### 944-SPEC - 944SPEC - low cost wheel to wheel racing

Body (6-10) Posted by joepaluch - 07 Nov 2009 22:57

These are PROPOSED changes gather from the various discussions. Use this area to further discuss these. Based on the feedback we get the rules will be changed (or not) to reflect these updates. It is anticipated that some rules changes will NOT be accepted, but all are up for debate.

### 9 Lexan Windshield

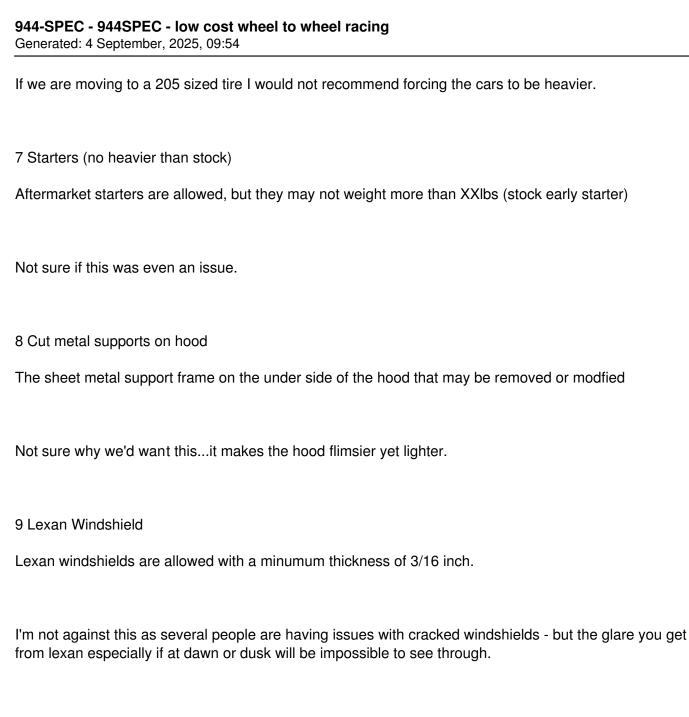
Lexan windshields are allowed with a minumum thickness of 1/4 inch. (EDITED 11/24/09, Was 3/16)
